## PUBLIC UTILITIES COMMISSION

**Re: Data Request #23 for the SCE Ivanpah-Control (I-C) Project (A.19-07-015)**

## ENVIRONMENTALLY SENSITIVE AREA 1.5 MILES NORTH OF LONE PINE, CA

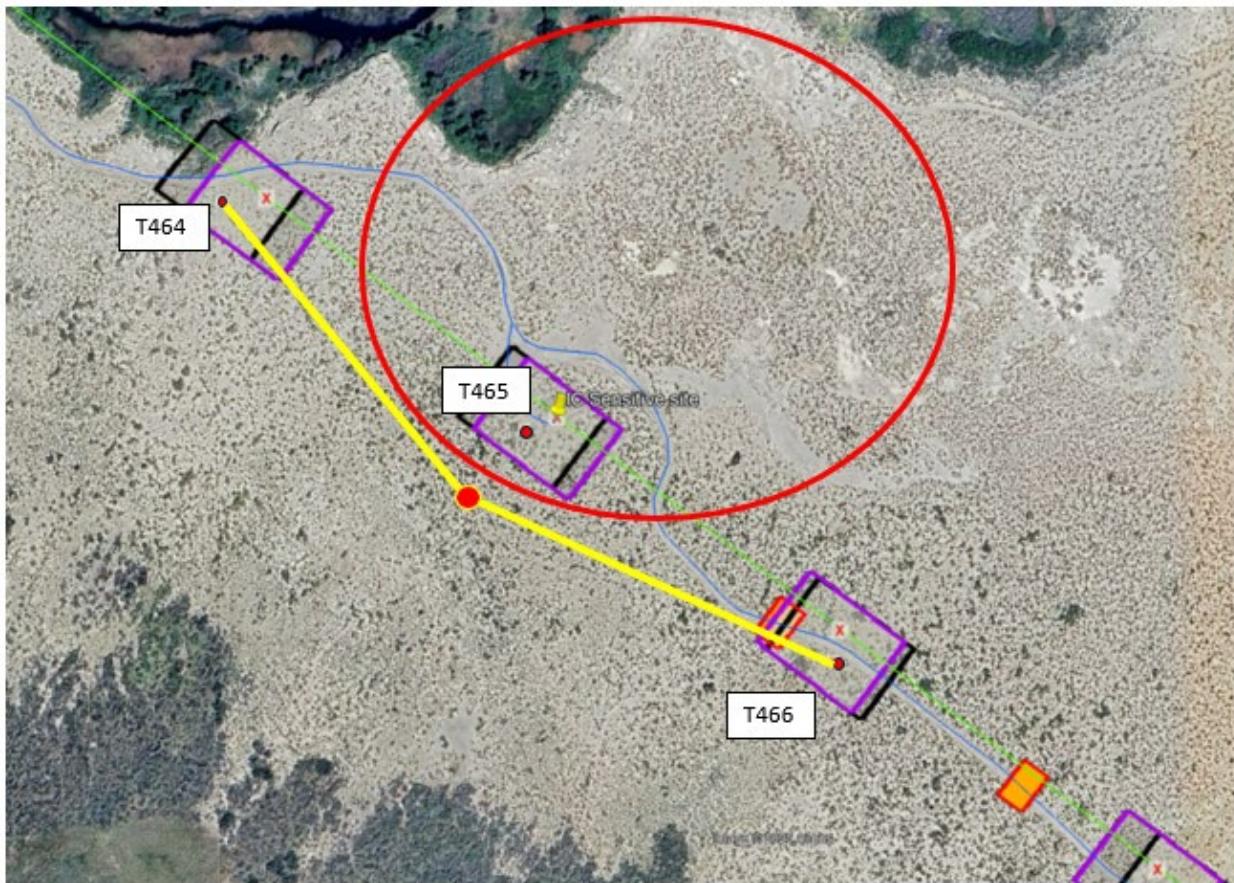
The analysis of cultural resources has identified an environmentally sensitive area (ESA) that needs to be avoided by project construction. The area is located surrounding and primarily northeast of New Structure 465, which is located about 1.5 miles north of the town of Lone Pine (see map on next page).

We request that SCE evaluate the feasibility of a single-structure and access road reroute, in which structure 465 and a revised access road would be moved about 150 feet to the southwest. This would avoid impacts of structure construction within the ESA.

**In order to avoid any new disturbance within an Environmentally Sensitive Area (in the red circle) around and northeast of Structure 465, please evaluate moving Structure 465 about 150 feet to the southwest, as shown above. It appears that the landowner is the same party in both locations.**
